**CRITIQUE OF ICF-CLEMENT'S
RISK ASSESSMENT OF THE TYSON'S SITE**

14 September 1986

**CIBA-GEIGY Corporation
Ardsley, New York
10502-1699**

**Environmental Resources Management, Inc.
999 West Chester Pike
West Chester, PA 19382**

Figure 3-1A
Generalized Geologic Cross Section
As Presented and Used By EPA in the FFS

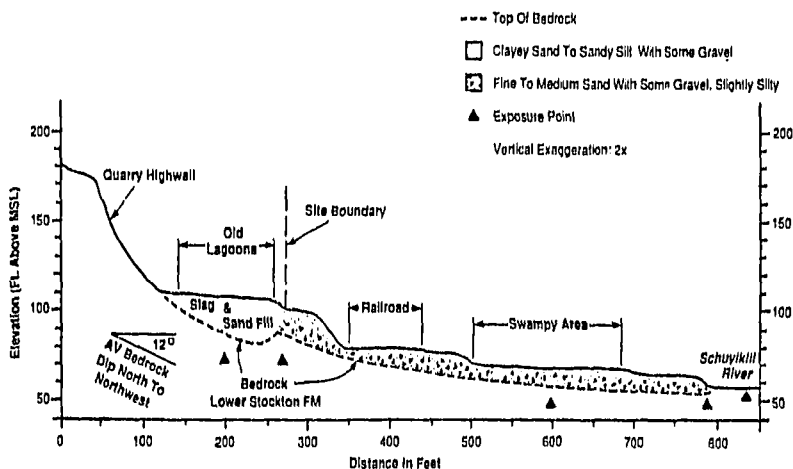
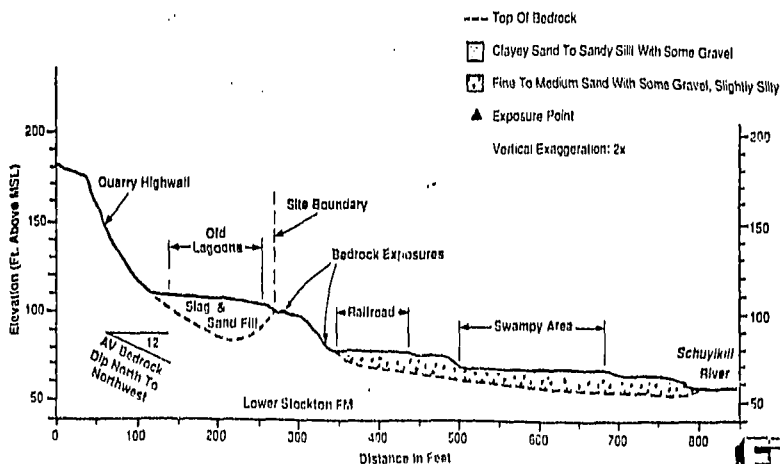
ICF-Clement failed to properly interpret the geometry and characteristics of the geologic system. Figure 3-1A is a geologic cross section from the ICF-Clement RA; Figure 3-1B is the same figure drawn to show actual field conditions based on ERM's field investigation. The fundamental difference between the two cross sections is that ERM's cross section (based on between actual field conditions) shows the interruption of continuity the unconsolidated material in the lagoon area and the off-site overburden by a bedrock outcrop extending between the former lagoons and the railroad tracks. Failure to understand the geologic conditions is a serious flaw in the definition of contamination migration pathways. Potential contamination of river water will not result only via ground water flow through the lagoons and the unconsolidated material to the river. The bedrock system is obviously an integral part of the migration pathway which was omitted in the modeling by ICF-Clement. (Refer to Section 3 of ERM's response to the FFS for a more detailed discussion of the relationship between the shallow and deep aquifer and the probable effect on contaminant migration).

The referenced geologic cross-sections are given here in Figures 3-1a and 3-1b. The cross-sections clearly show the lagoon area situated directly on bedrock. Although a slight artesian condition existed during R.I. sampling, the process of concern should have been the movement of non-aqueous phase liquids (NAPL's) into the underlying fractured bedrock. Since the R.I. had clearly stated the possibility of direct contaminant movement into bedrock; the RA should have fully evaluated this concern and therefore considered contaminants which had migrated into bedrock as a potential source of contamination. Given the presence of DNAPL in bedrock (as identified during ERM's ongoing study of the deep or bedrock aquifer), both the exposure points used by ICF-Clement (located in the surficial aquifer) and the overall assessment of contaminant migration from the site to the river are inappropriate. A complete discussion of the relationship between the shallow or so called "surficial aquifer" and the deep or bedrock aquifer is given in Section 3 of ERM's response to the FFS. A discussion of the behavior of DNAPL's and its importance to the Tyson Site is given in the S. Feenstra and J. Cherry report.

Figure 3-1B
Generalized Geologic Cross Section
As Modified By ERM,
Based Upon Actual Field Data,
To Show True Site Hydrogeologic Conditions
